**11 June 2009**

**Request for review – 2410 Sichuan Liangtan Hydropower Station Second Phase Project**

**Figure 1** Trend of tariffs approved in the the Sichuan province<sup>2</sup>

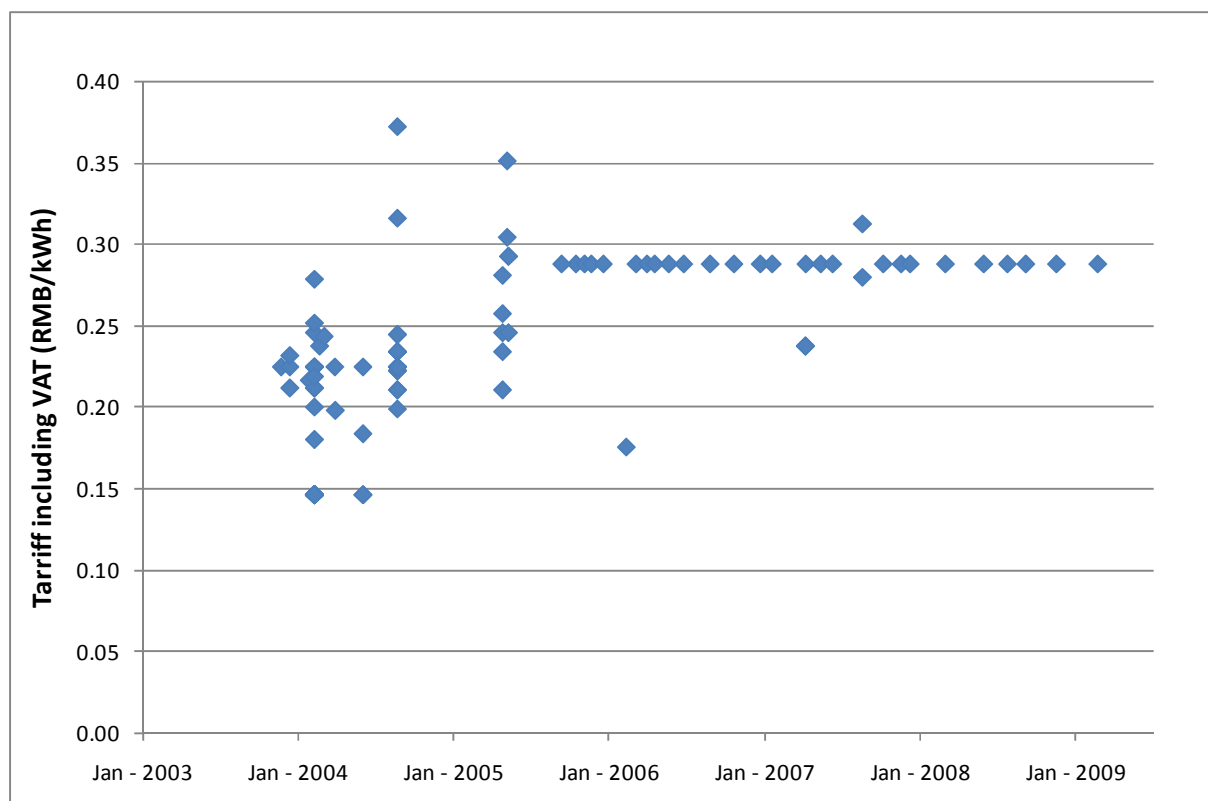
1. Further explanation should be provided regarding: (a) the basis for the assumed electricity tariff in the PDR (b) The revised assumed electricity tariff used in the PDD submitted for registration, in particular, (i) how the price of 0.270 RMB/kWh (including VAT) agreed by the PP with the grid company has been derived and whether this tariff is in line with the general trend for similar projects exporting electricity to the same grid, which commenced after 2002, and (iii) how this tariff compares to the tariffs for thermal power plants.

In March 2005, The National Development and Reform Commission, which regulates power production, issued the “Provisional Measures for the Administration of On-Grid Electricity Tariffs” – document NDRC [2005] NO.514, which aims to regulate the determination of the electricity tariff offered to power producers in order to stabilize tariffs and increase competitiveness in the electricity market. Since then, consistent tariff guidance policy has also been issued in Sichuan Province: according to recent regulations (ChuanJiaFa (2005) No.91, ChuanJiaFa (2005) No. 123 and ChuanJiaFa (2006) No.145), the guide electricity tariff for hydropower plants regulated by Sichuan Provincial Price Bureau has not been increased over the past 3 years; the tariff has consistently been set at 0.288 RMB/kWh including VAT for newly operational hydropower plants. Figure 1 shows the trend of tariffs approved in the Sichuan Province since 2003, it can be seen in figure 1 that since October 2005 almost all tariffs have followed the guide electricity tariff of 0.288 RMB/kWh.

As mentioned above, the PPA that was signed in September 2007 set the tariff for one year, in September 2008 a new PPA was signed. The tariff in the new PPA was 0.288RMB/kWh including VAT to be consistent with the tariff guidance described above. This further demonstrates that the tariff assumed in the PDD, 0.360 RMB/kWh including VAT, is conservative.
